Model: CDP-XA7ES**No.** 529**Subject:** Disc Tray Will Not Open**Date:** May 23, 1997**Symptom:****(22)**

SERVO BOARD**LOADING SWITCH BOARD**

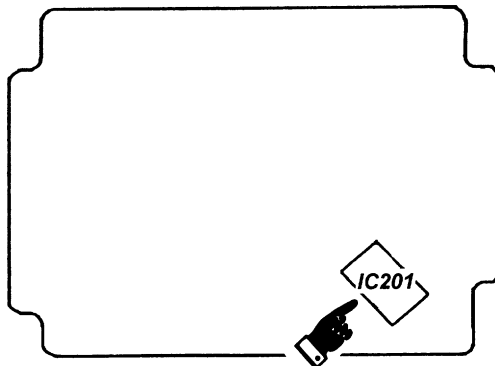
If the customer complaint is any of the following:

- 1.) While in PLAY mode or STOP mode the Disc Tray does not respond when the OPEN/CLOSE button is pushed.
- 2.) If the EDIT FADE TIME is set to 10 minutes and the power is switched ON/OFF the fade time changes to 5 minutes.

Replace the Microprocessor and resistor listed below.

REF	FORMER		NEW	
	DESCRIPTION	PART NUMBER	DESCRIPTION	PART NUMBER
IC201	CXP84120-025Q	8-752-864-35	CXP84120-064Q	8-752-883-09
R281	680 OHM 1/4W	1-247-711-11	6.8K OHM 1.4W	1-249-415-11
